**Subject: SOUTHERN CALIFORNIA PUBLIC POWER AUTHORITY'S  
DATA ADEQUACY SUPPLEMENT  
CANYON POWER PROJECT, Docket 07-AFC-9**

# Data Adequacy Responses

## CANYON POWER PLANT

**CANYON POWER PLANT  
APPLICATION FOR CERTIFICATION  
RESPONSE TO CEC DATA ADEQUACY REQUESTS  
07-AFC-9**

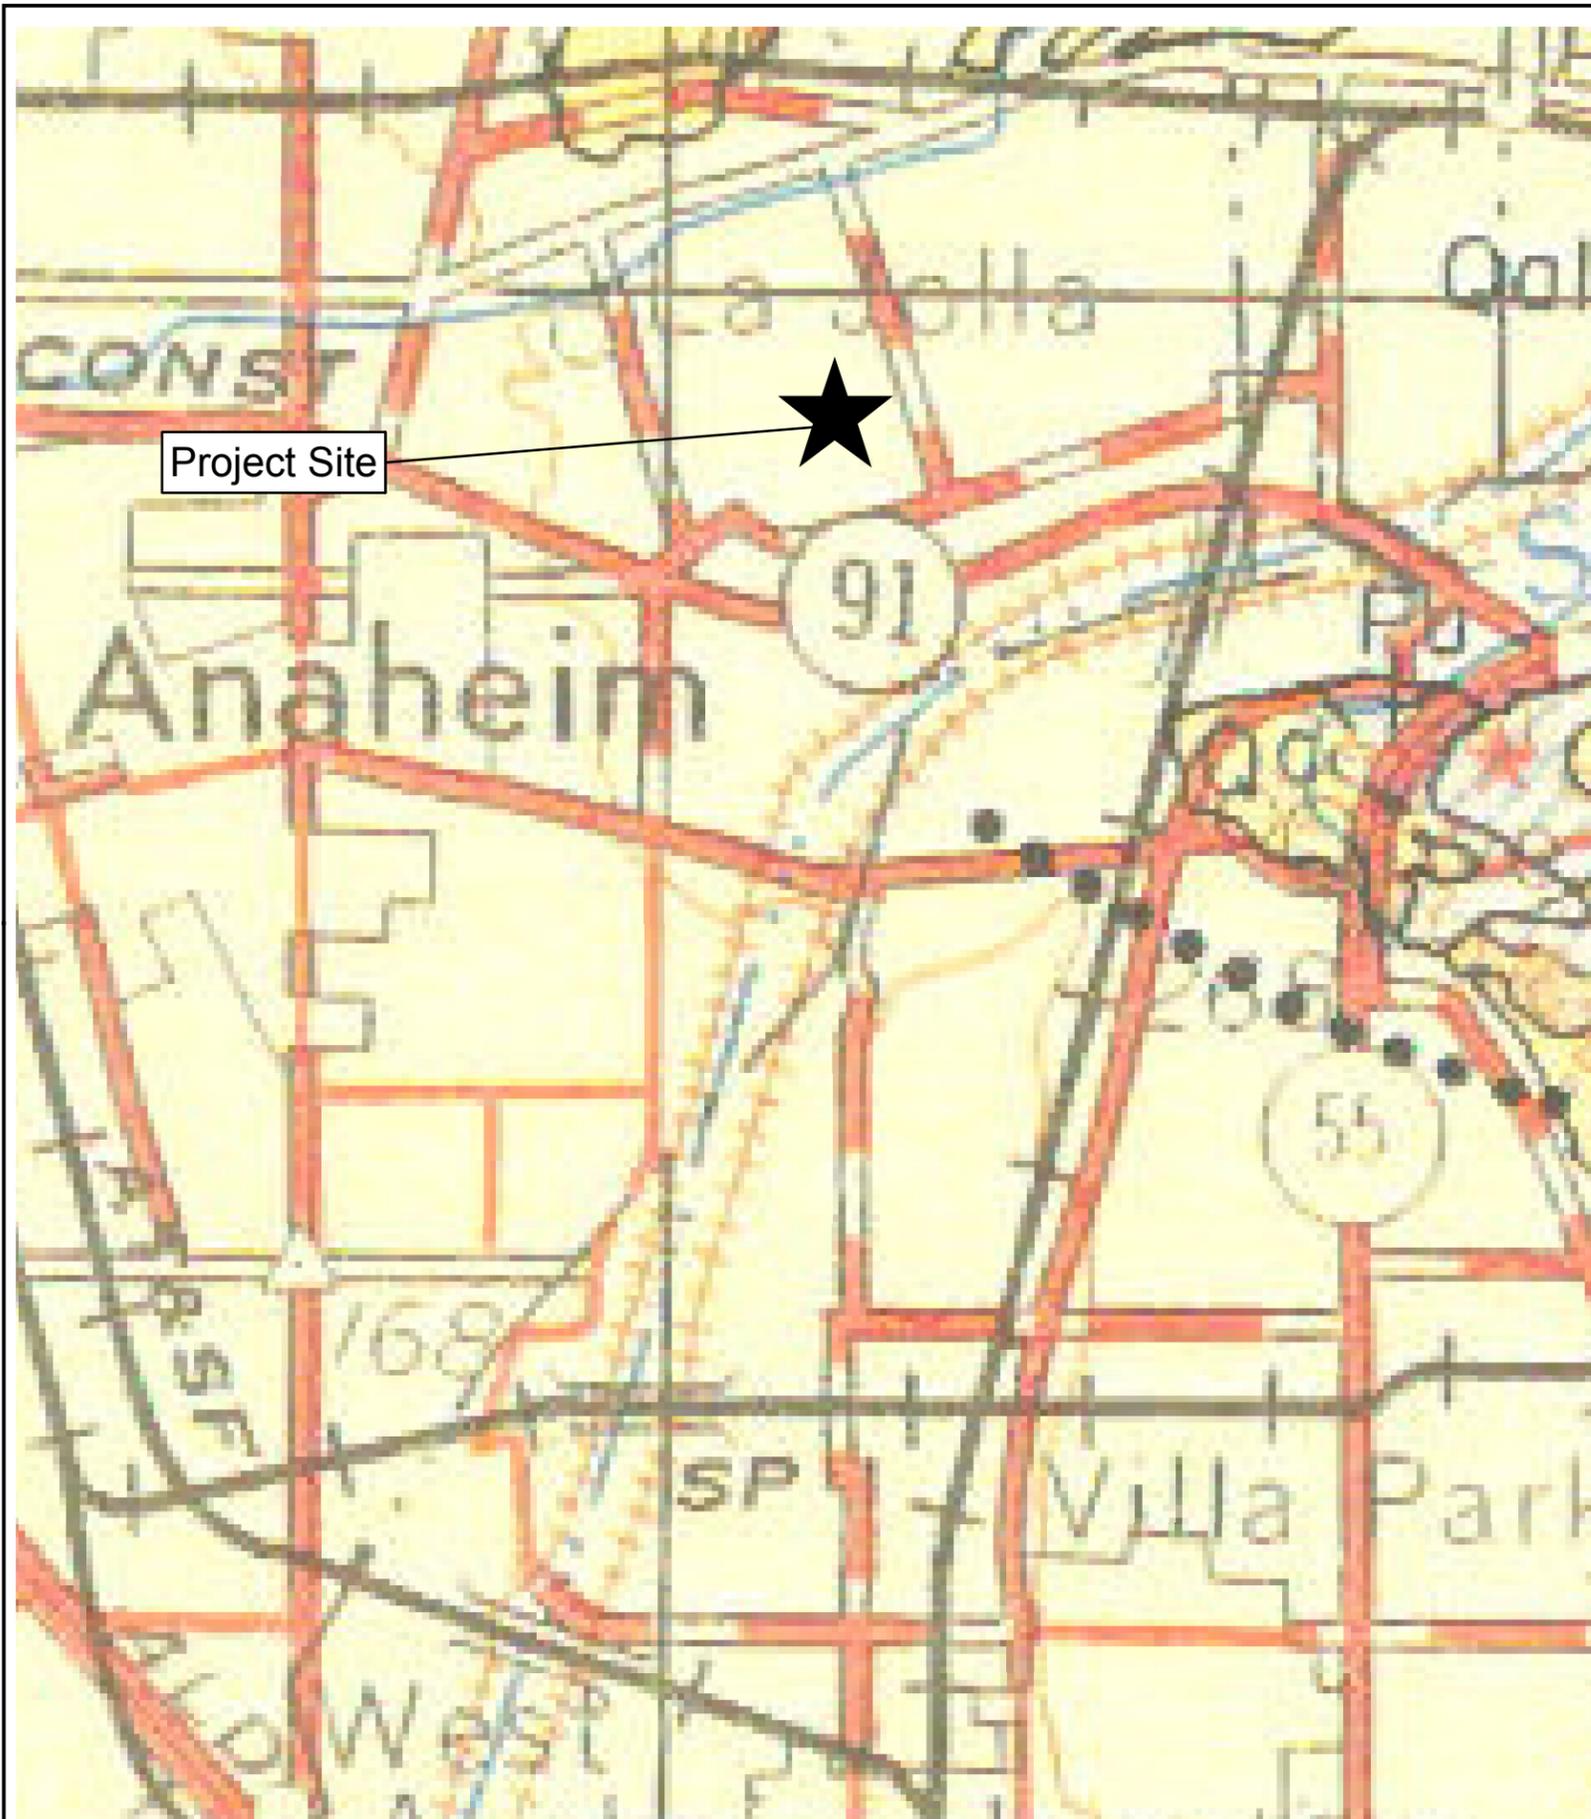
Figure 6.3-1 of the AFC was amended to represent a 1:24,000 scale, for CEC reference, and it is attached herein.

Anaheim SCPPA	<b>FIGURE 6.11-1</b> <b>REGIONAL VICINITY</b>	September 2007
City of Anaheim, California		28906973

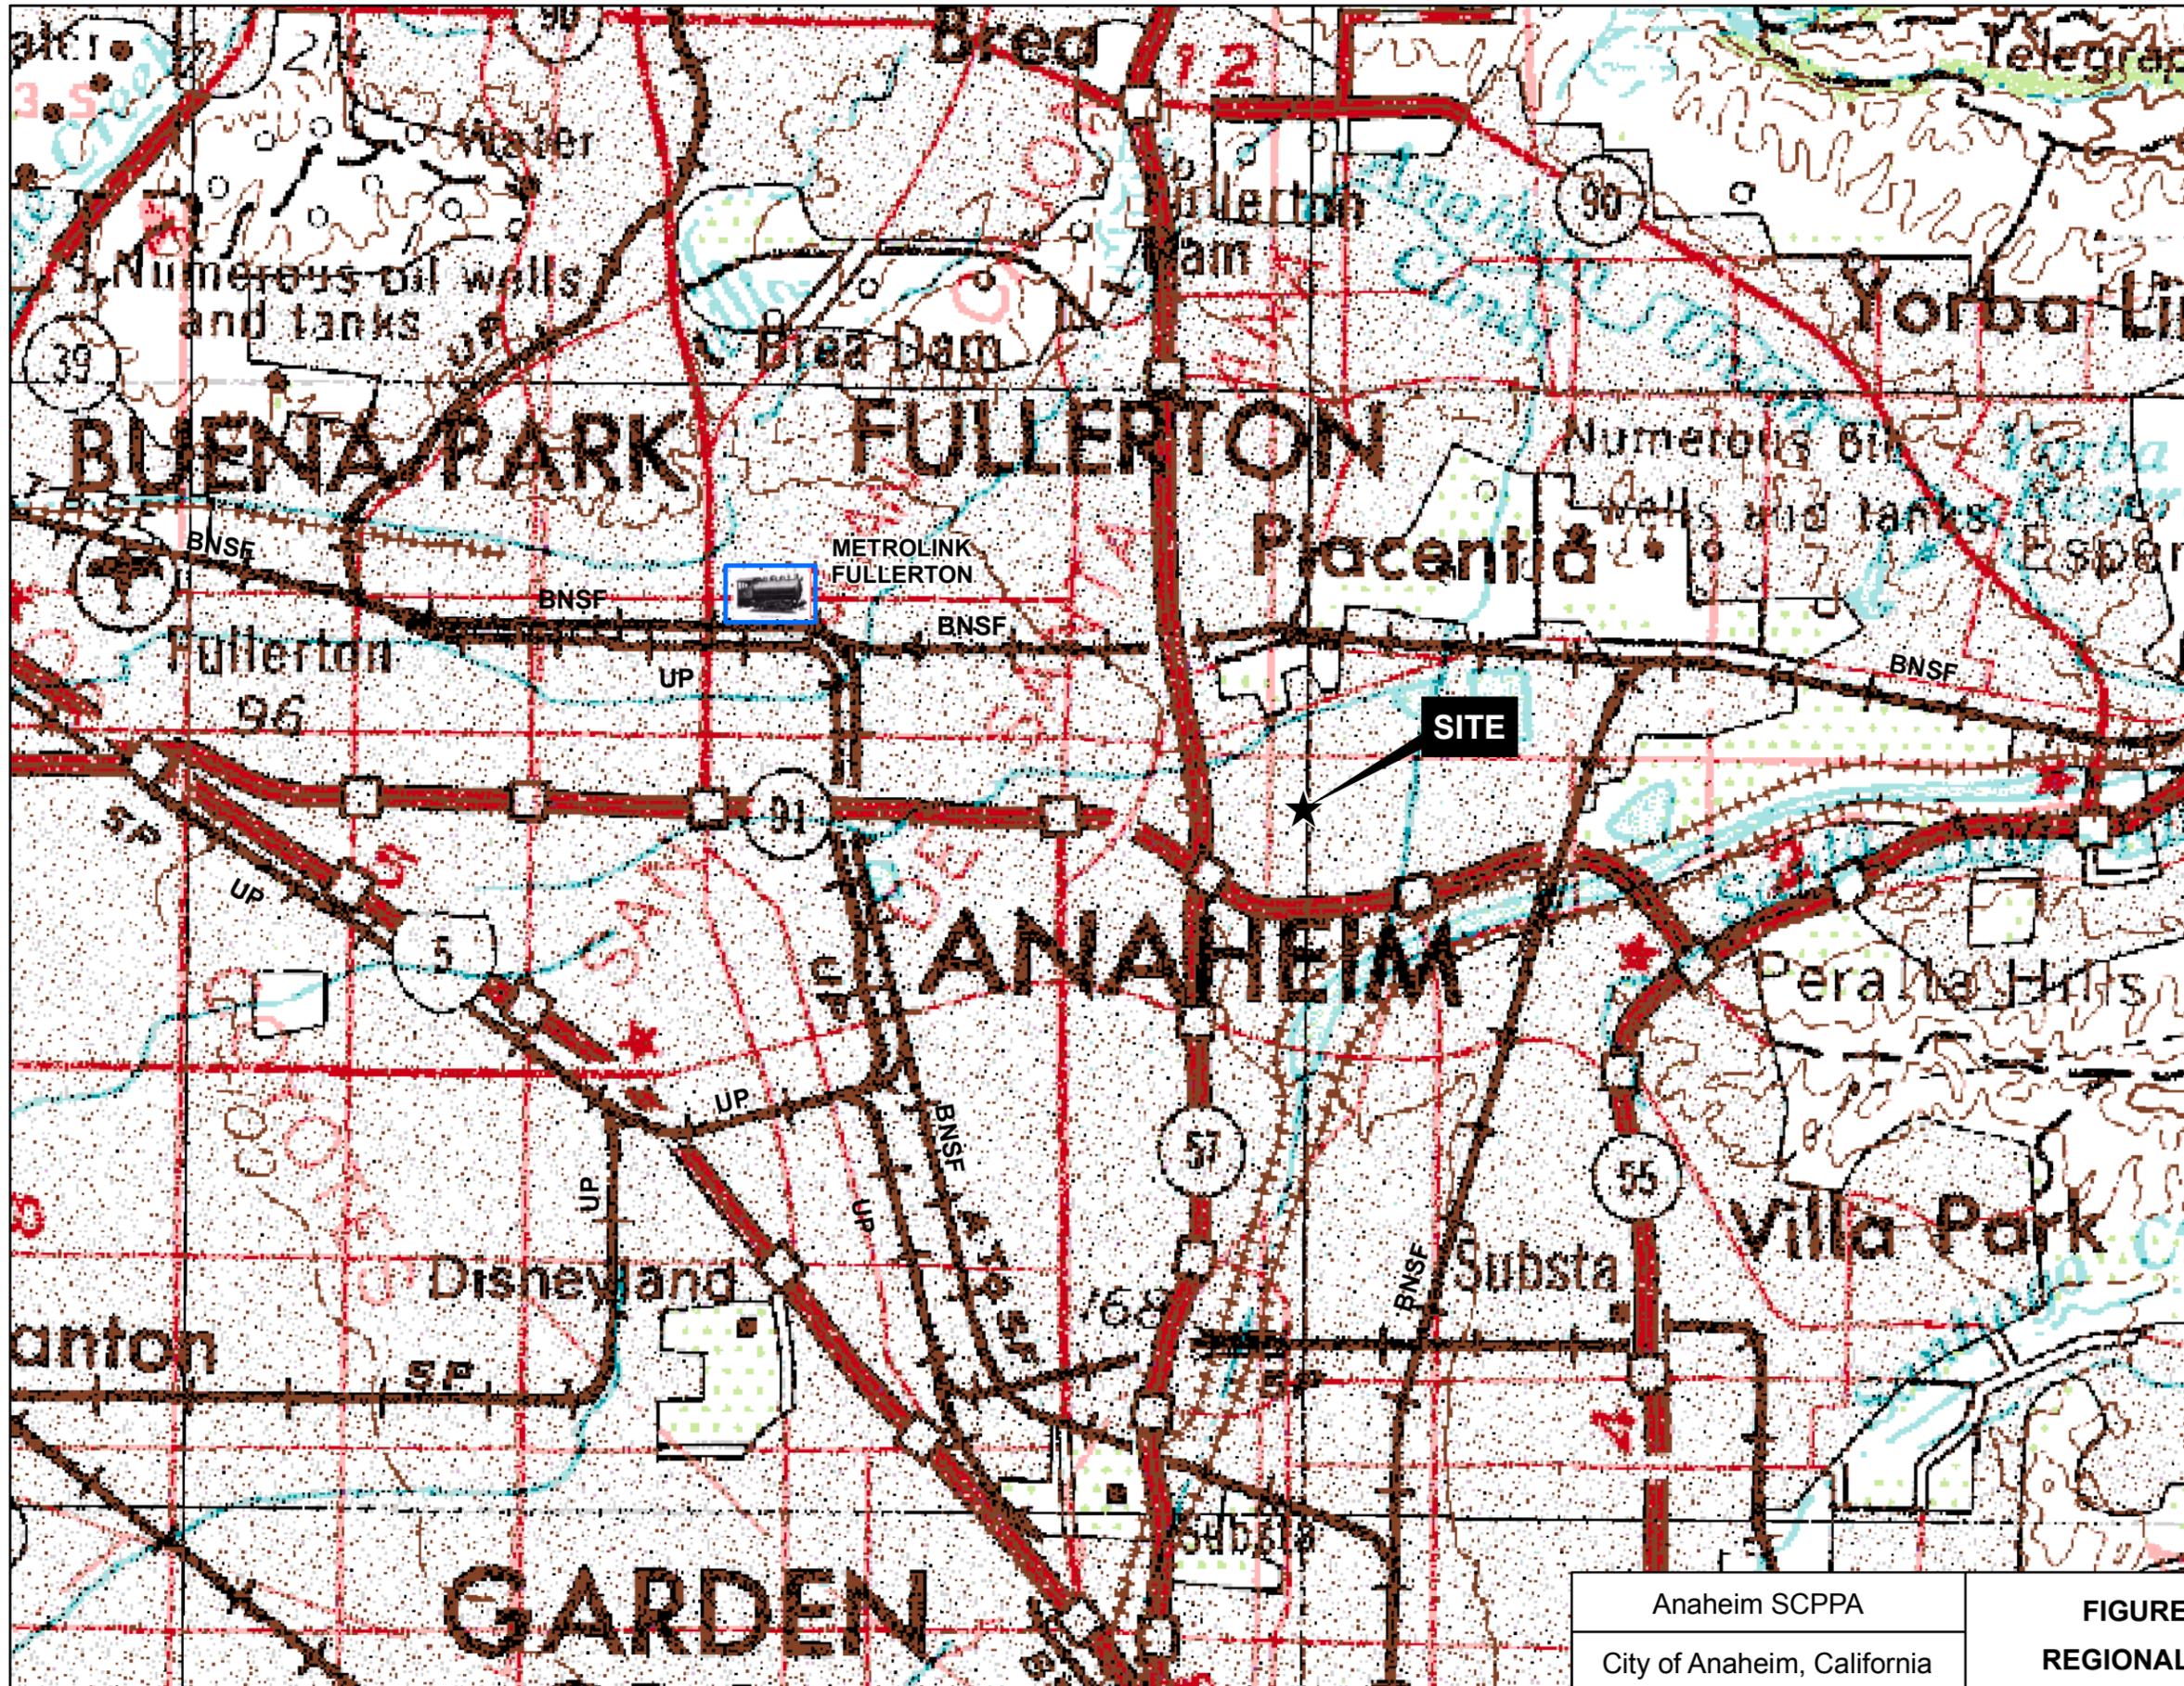
Figure 6.11-1, attached, was updated in response to CEC Staff comments.

Anaheim SPPA City of Anaheim, California	<b>FIGURE 6.11-2</b> <b>REGIONAL VICINITY</b>	September 2007  28906973
---	--	--------------------------------

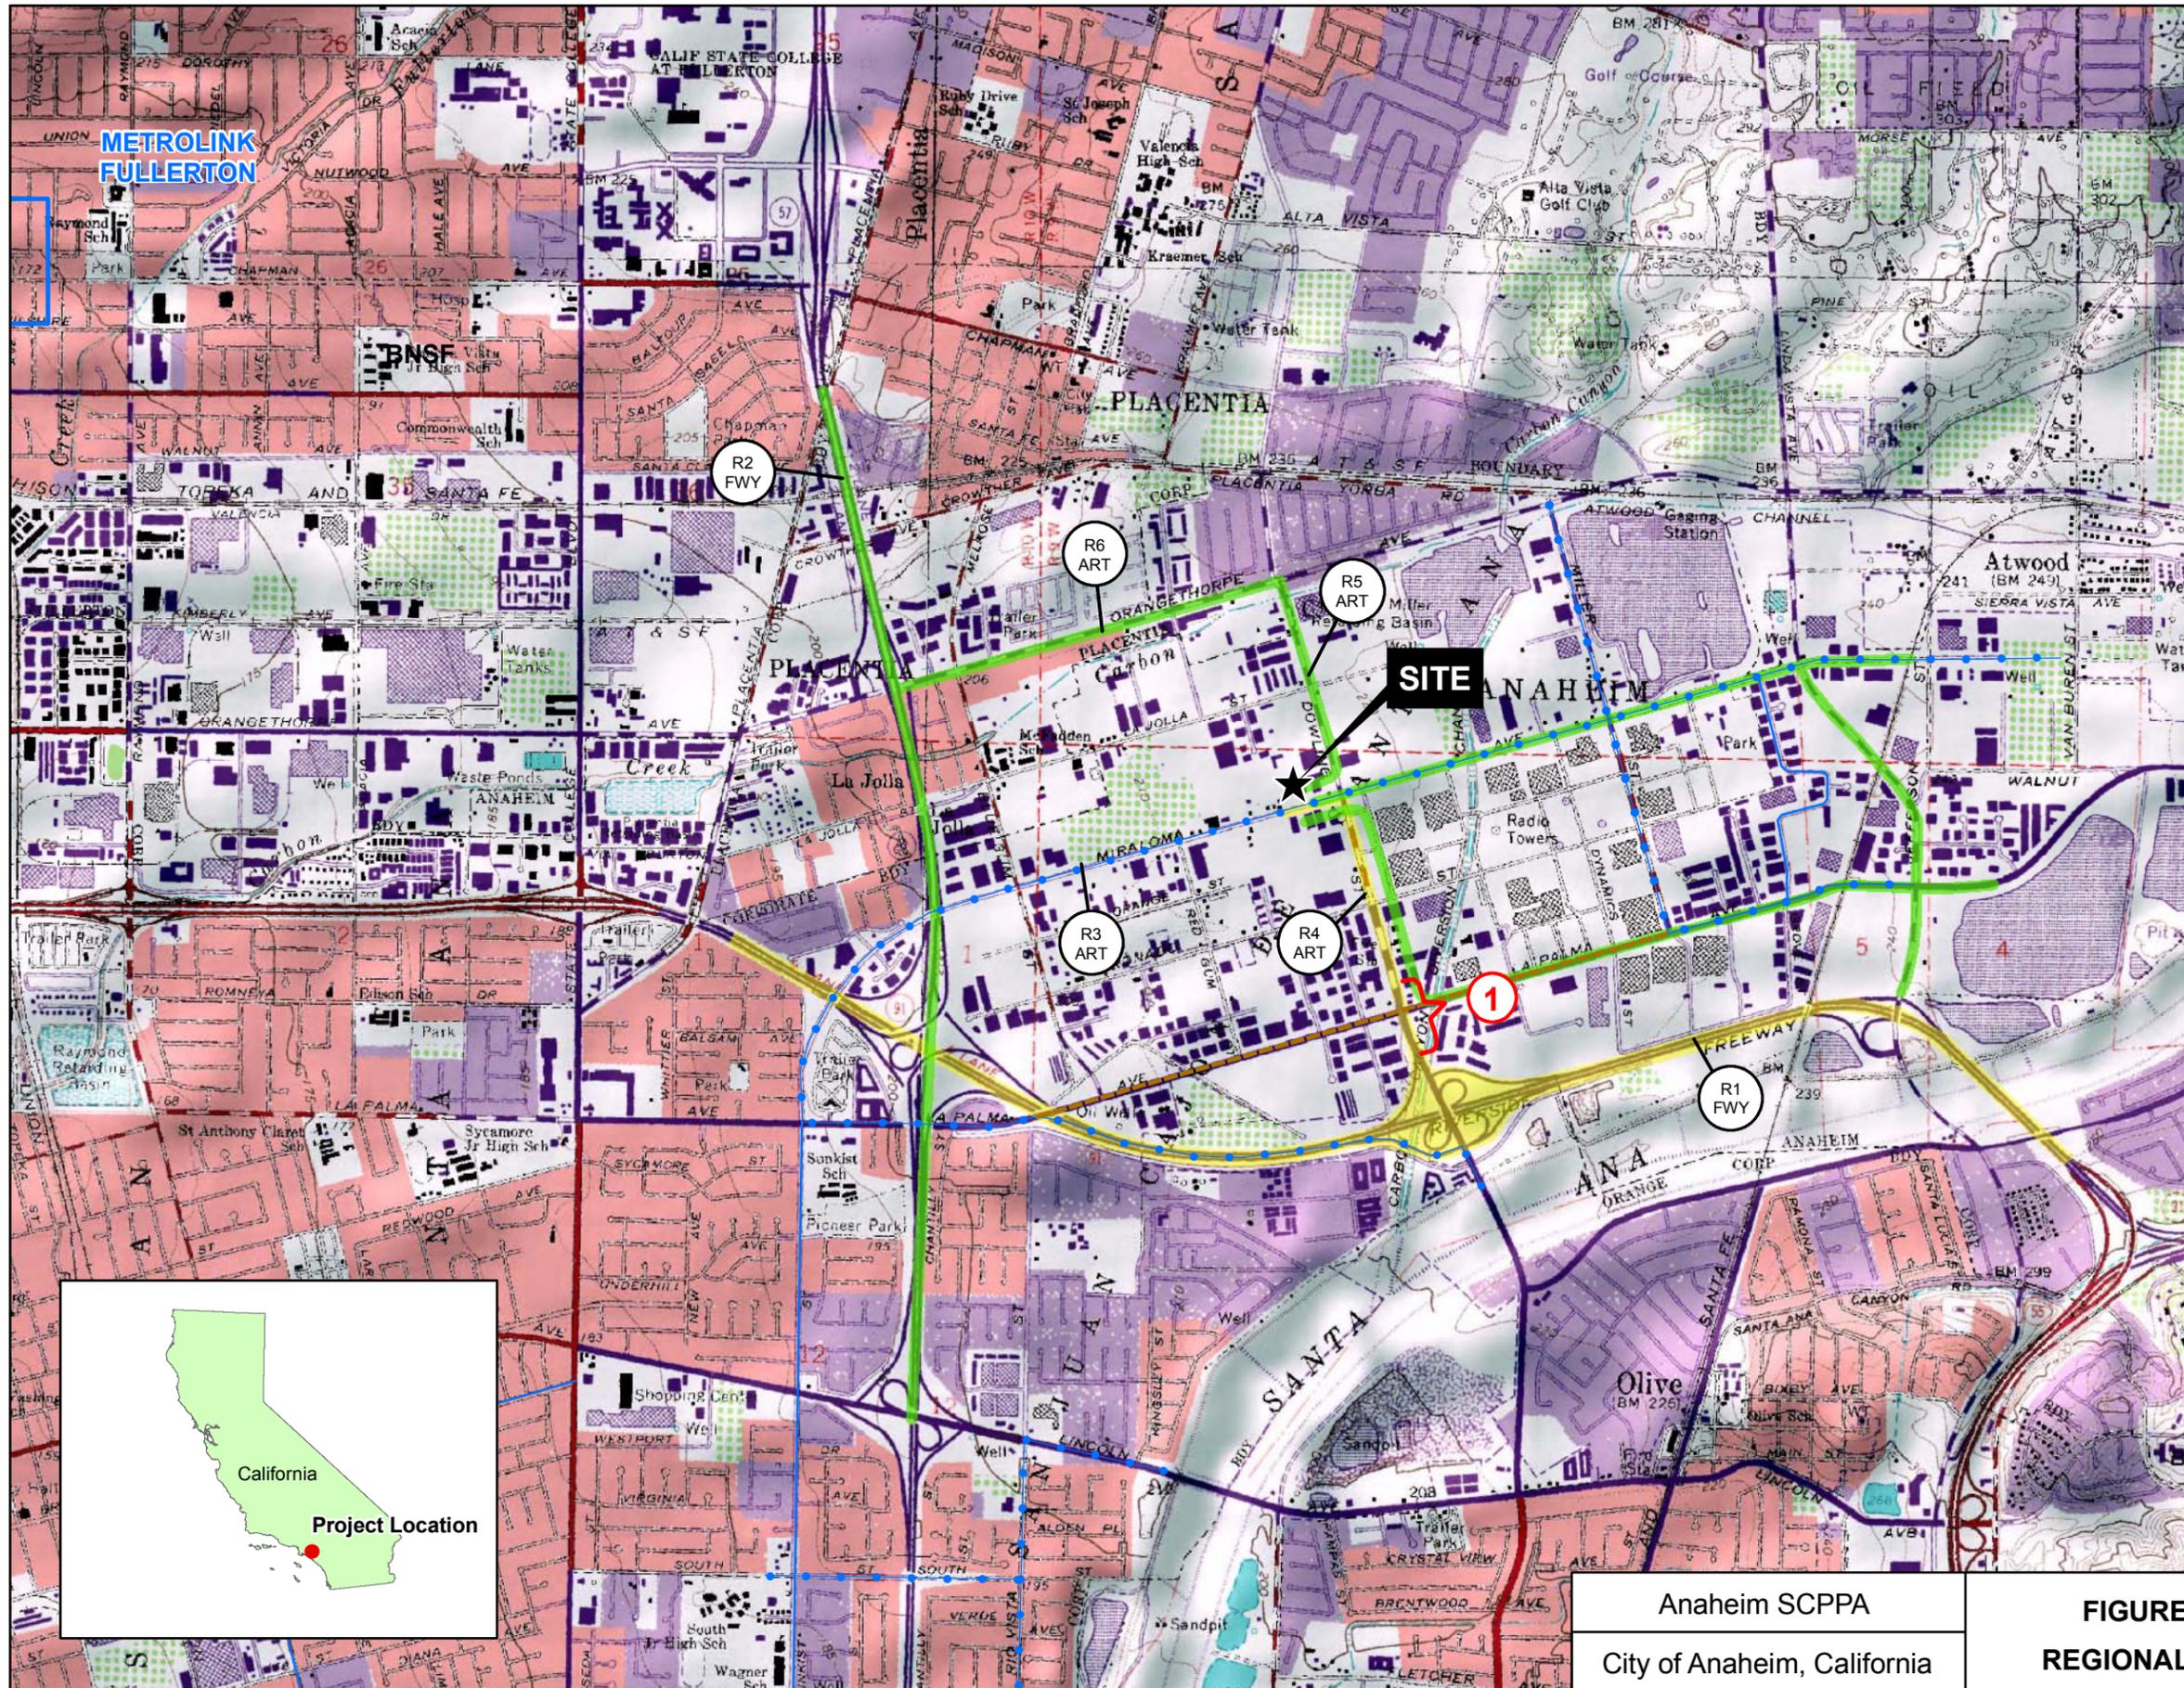
Figure 6.11-2, attached, was updated in response to CEC Staff comments.
